P 518004

ON-SITE SEWAGE DISPOSAL SYSTEM HOWARD COUNTY HEALTH DEPARTMENT BUREAU OF ENVIRONMENTAL HEALTH

ADDRESS: 8365 Murphy Road PROPERTY OWNER: Kevin & Cathy Bennett

(A)

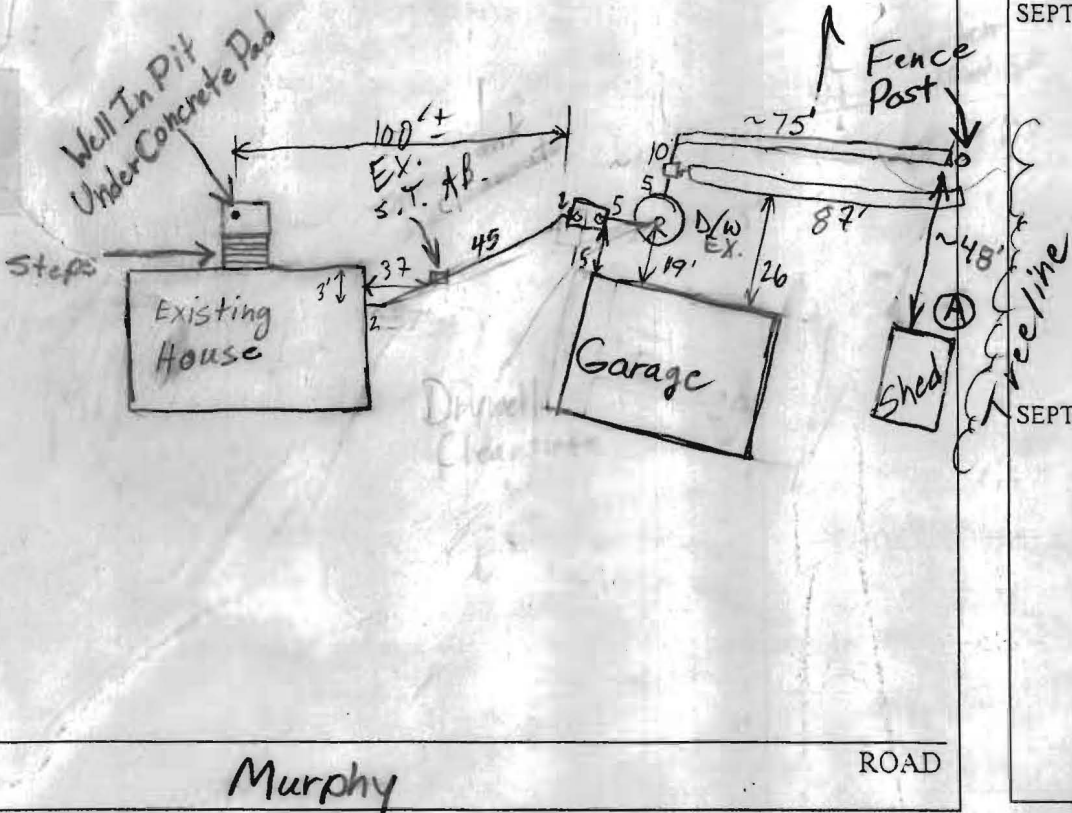
PRE-CONSTRUCTION 12/9/02 Existing trench off drywell still in good shape, added around 10 years ago as repair for drywell installation (per owner). Tear end untouched by sewage. Trench has stone from 4'-9+'. To add a distribution box and a second trench above the existing trench so that there is enough area for 3+ bedrooms. Trench to be 2' wide and 8.5'-9' deep with 5' of stone and 85'-90' in length. Tank to be moved closer to garage, preferably 100+' from well. Suggested using 1500 gallon. Also suggested replacing iron pipe.

(BB) 11/13/03 NEW TANK, TRENCH OK; ALL PIPE REPLACED; OK TO COVER
